Reference: Engineering Services
Miscellaneous Design | 14.004
2nd Floor Buildout – Purlin Support Frame – Field Modifications
Belmont Academy
Lake City, Florida

BELMONT ACADEMY
ROOF PURLIN MODIFICATIONS
03/15/2021

WF BM. TO PEMB RAFTER - FIELD MODIFICATION #1

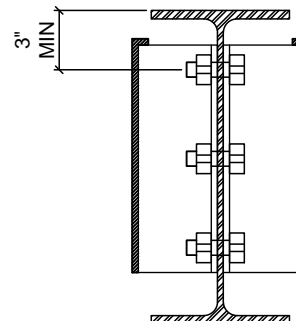
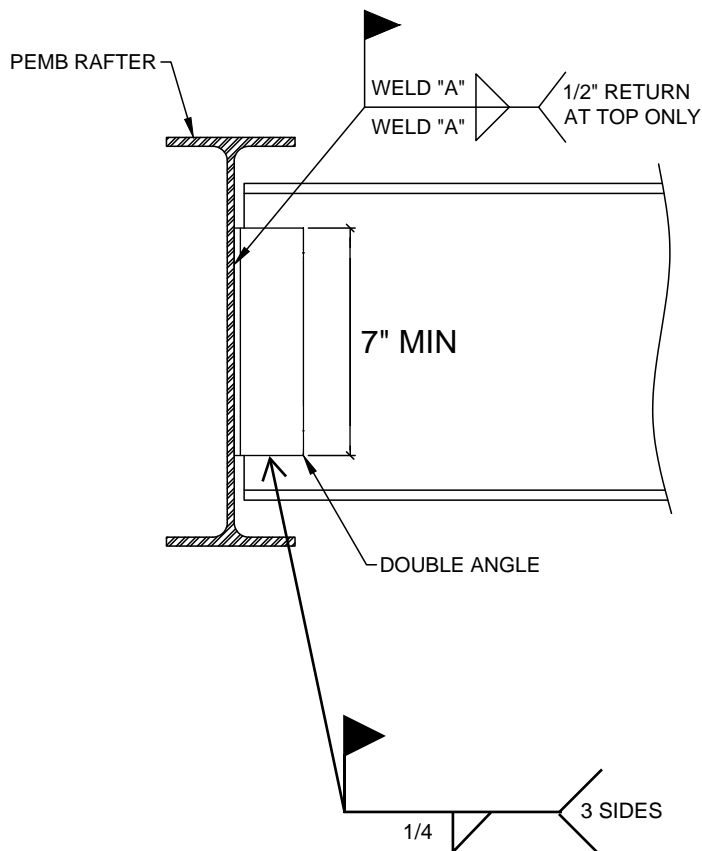
Modification #1: Double angles were welded, instead of bolted per detail SC-1.

- This modification is acceptable, refer to enclosed detail FM-1.

CONNECTION INFORMATION:
 ANGLE THICK. = 5/16" MIN.
 BOLTS = 3/4" DIA. A325N
 V, MIN = 1 1/4"
 WELD "A" = 1/4"

WF BM. TO PEMB RAFTER - FIELD MODIFICATION #2

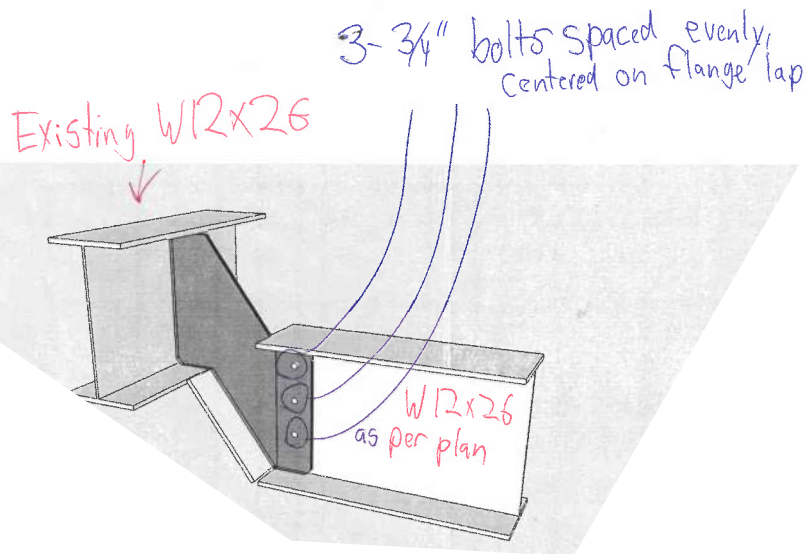
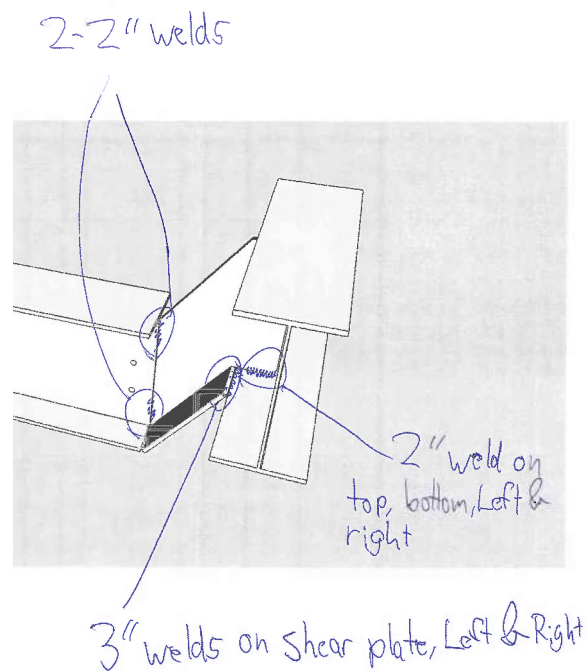
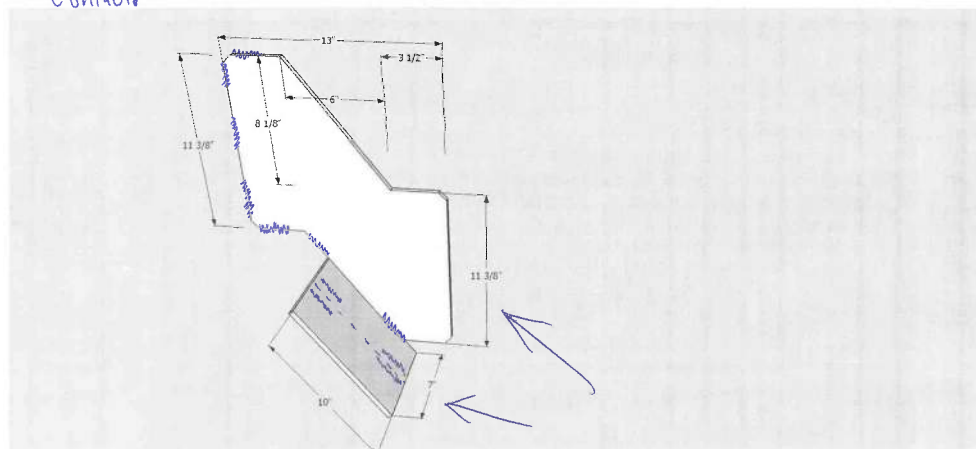
Modification #2: A built-up plate assembly was used in lieu of double angles per detail SC-1.

- This modification is acceptable, refer to enclosed detail FM-2.

2" fillet welds in 5 places of contact to the existing I beam, Same Left and right, total of approximately 20" of weld, per bracket-to-beam contact.

8"-10" of fillet weld on Shear plate-to-bracket contact. All 3/8 thick A36 steel plate
